## FTSW SUPPLY UPDATE

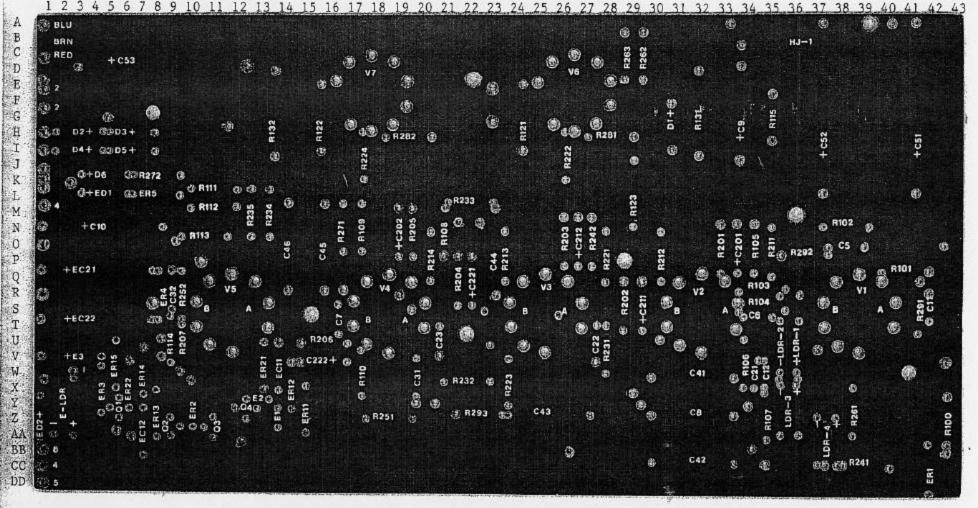
- 1. Change 680/2W, R131, at 6-32 to 1K/2W.
- 2. Change 4704/16v cap at F-34, C9, to 33004/16v (glue on top of board)
- 3. Check R115 at F-35, 330 ohms.
- 4. Voltage at c9 should be 8-10 v DC, Rhythm mode, 3 v DC Lead
